TOWN OF WILTON
ADDENDUM NO. 2

RFP #2022-09

**Request for Proposal to Replace Lovers
Lane Bridge - Bridge #04975**

ADDENDUM NO. 2

NE BARRIER WALL/WINGWALL 1B TERMINATION DETAIL

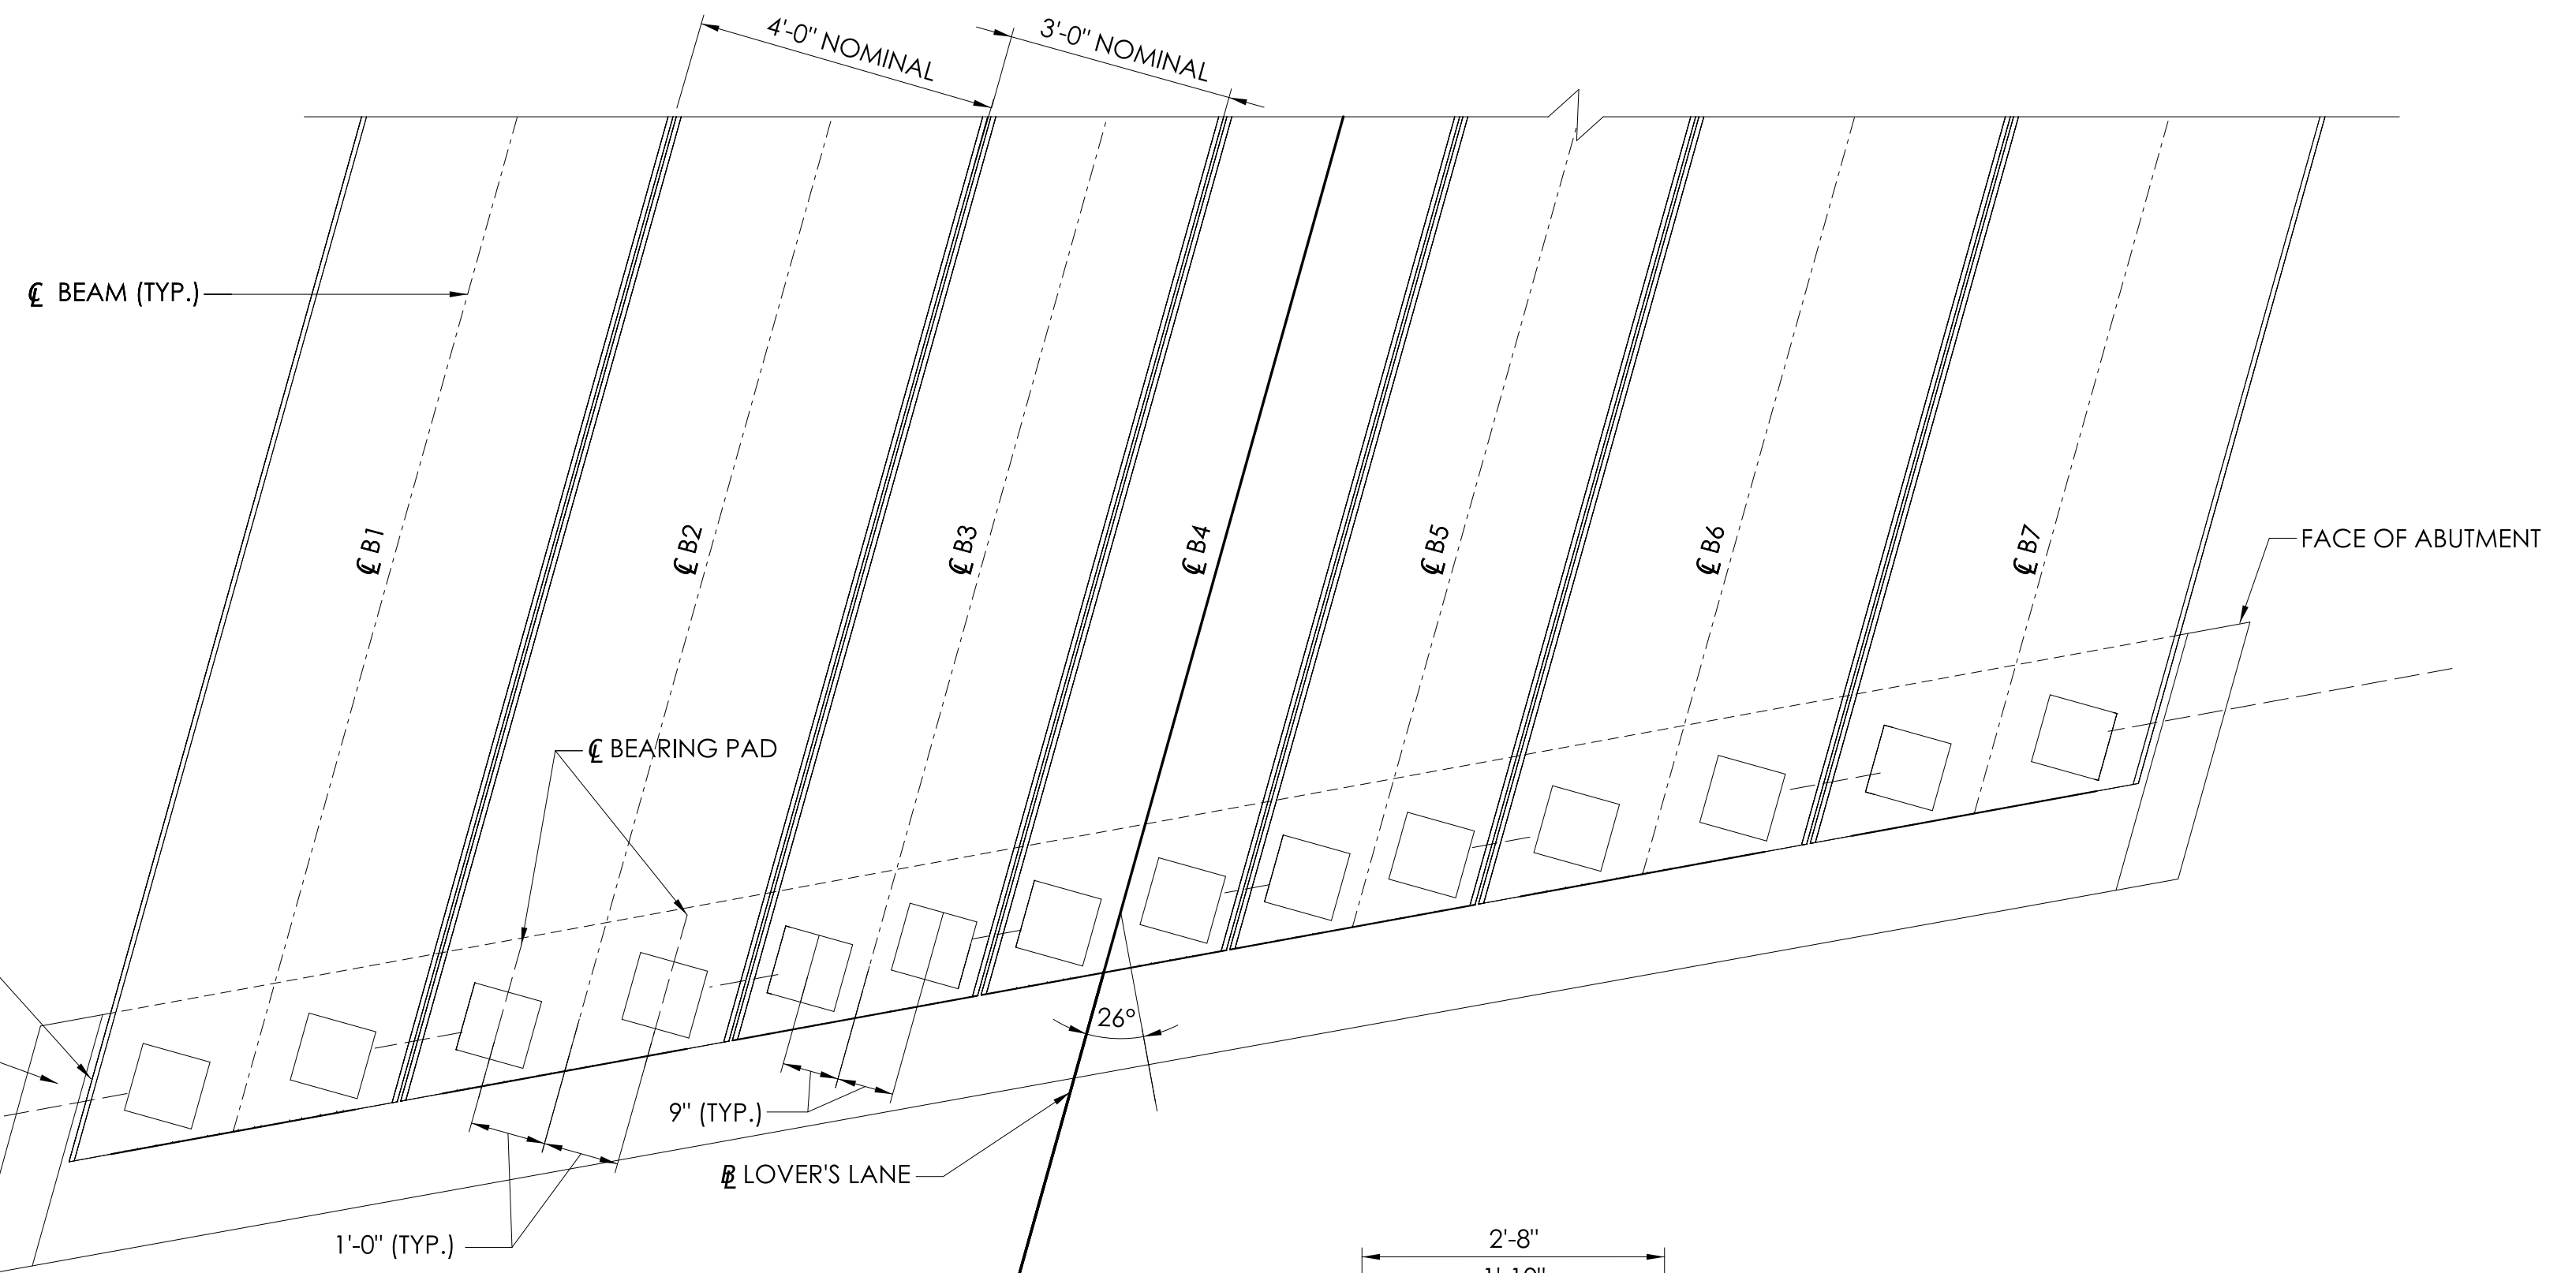
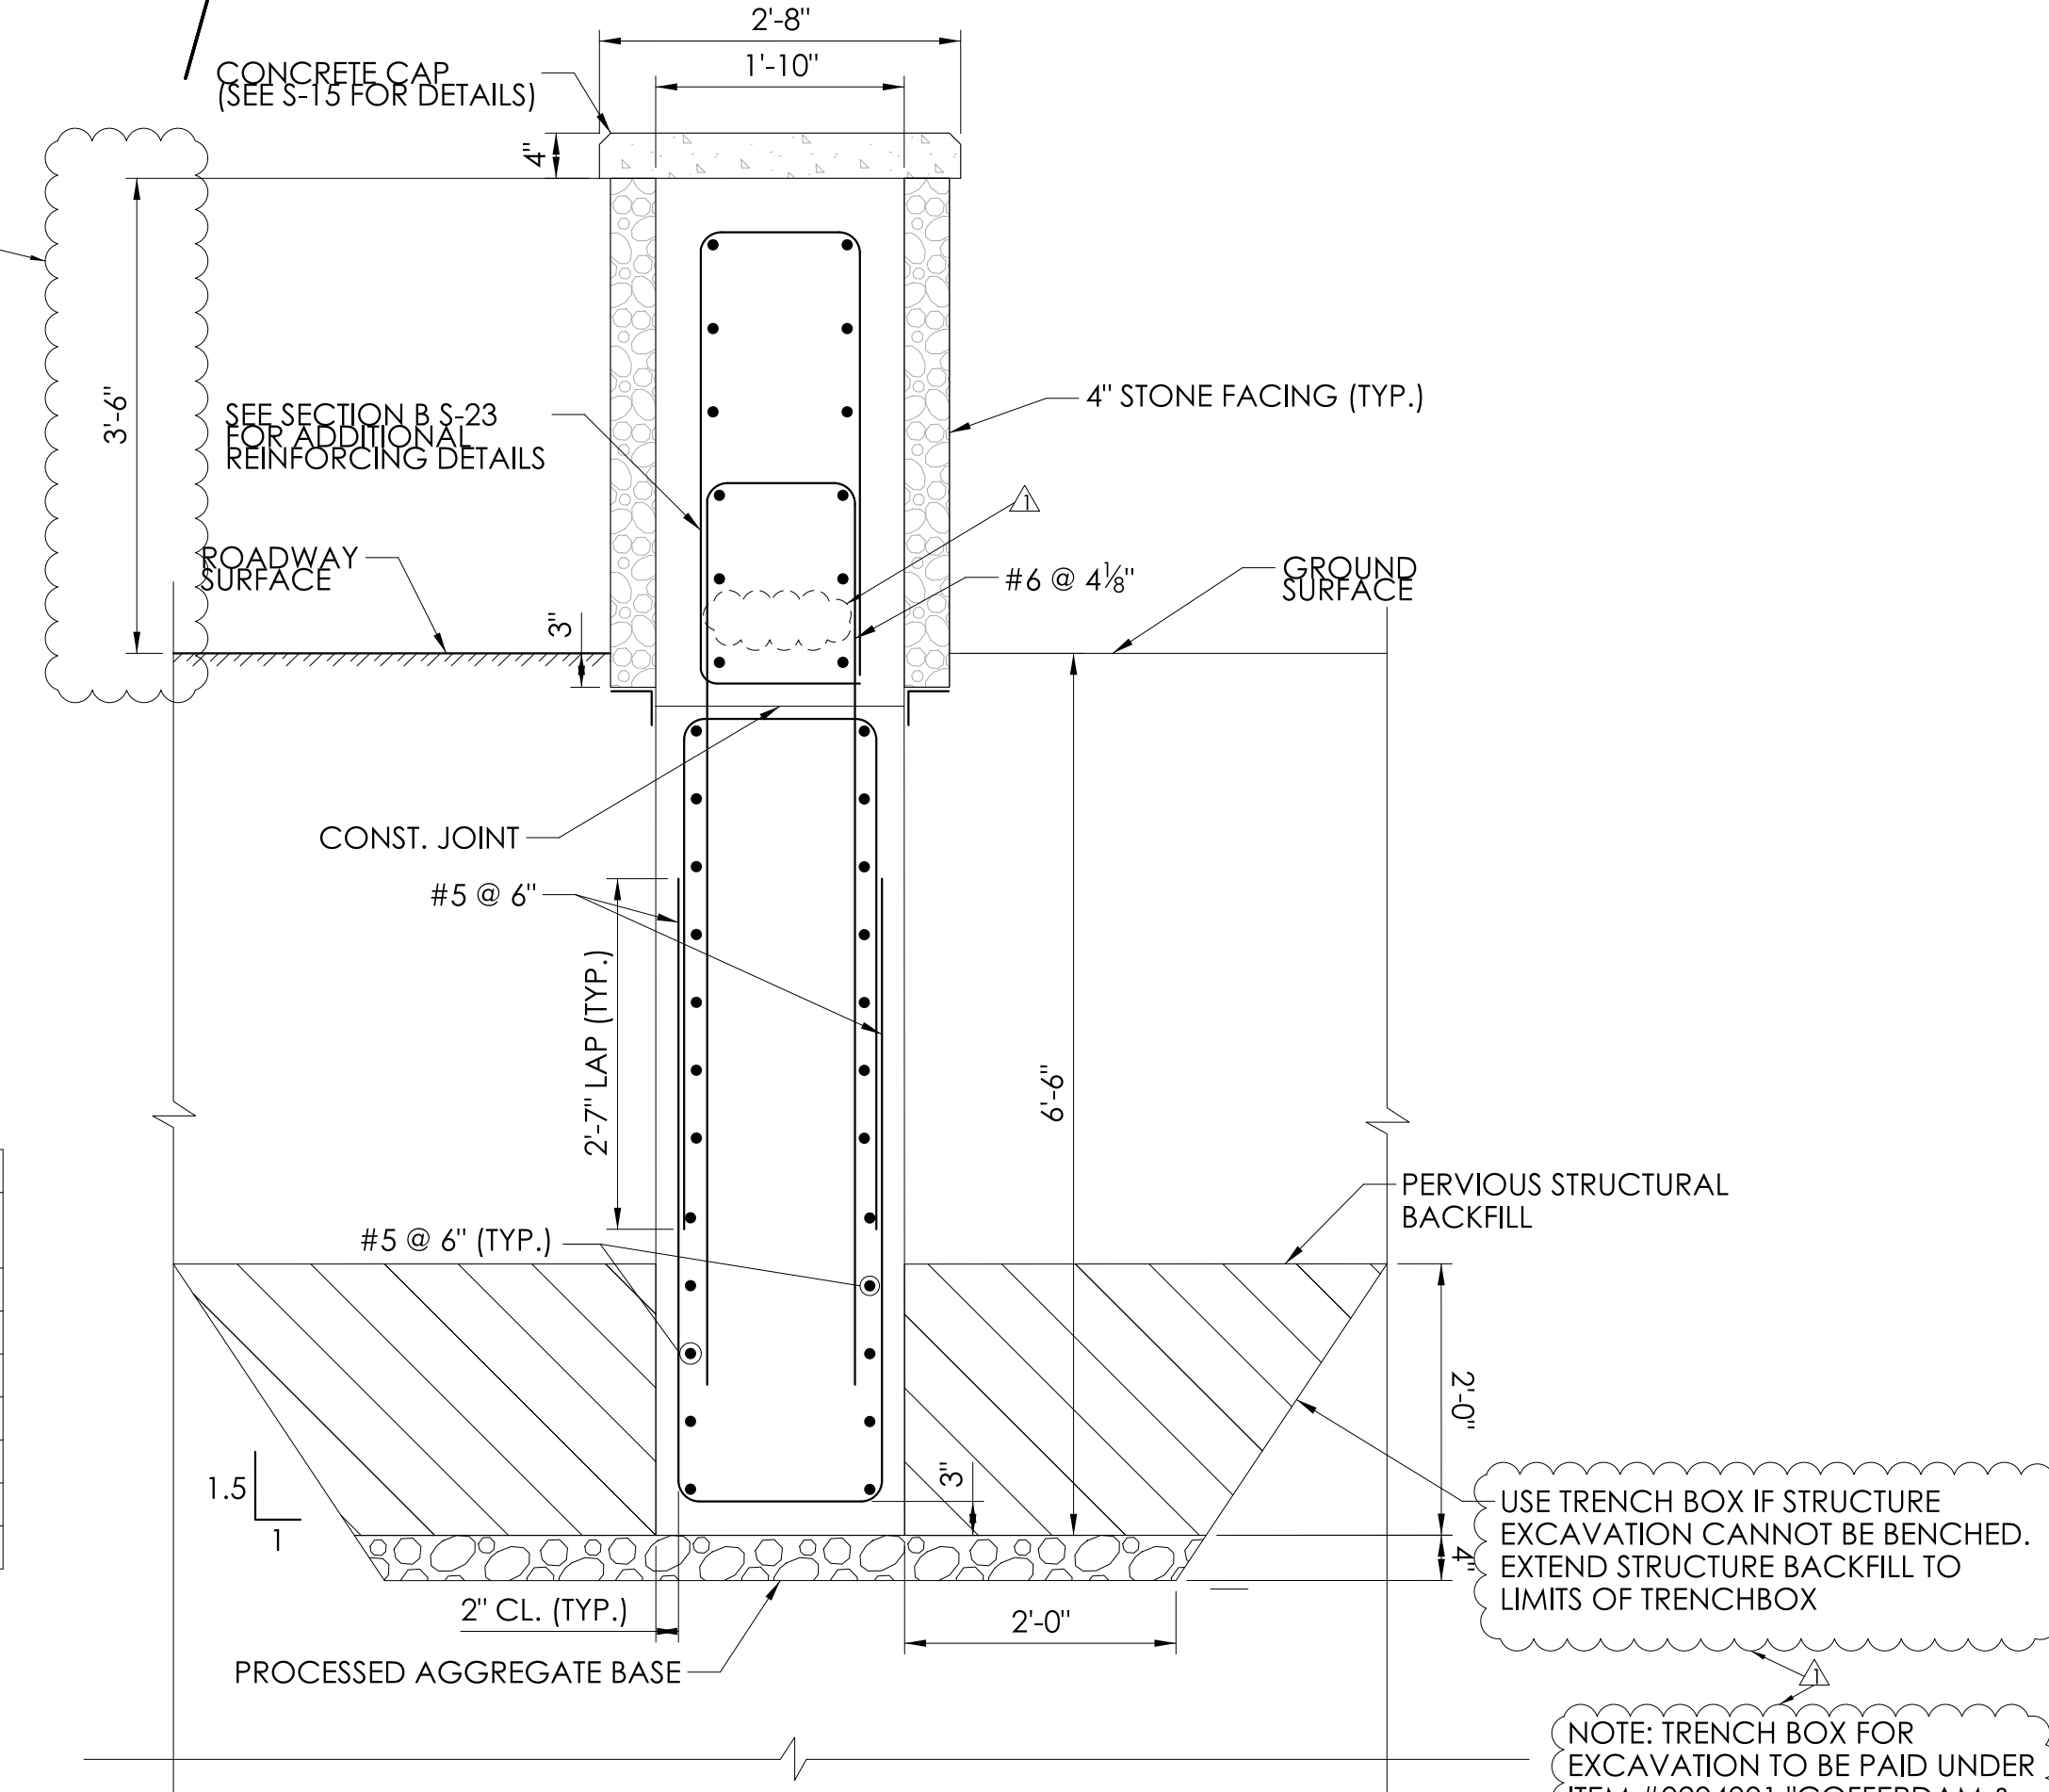
REV.	DATE	DESCRIPTION
1	12/15/22	BARRIER WALL/WINGWALL REVISE
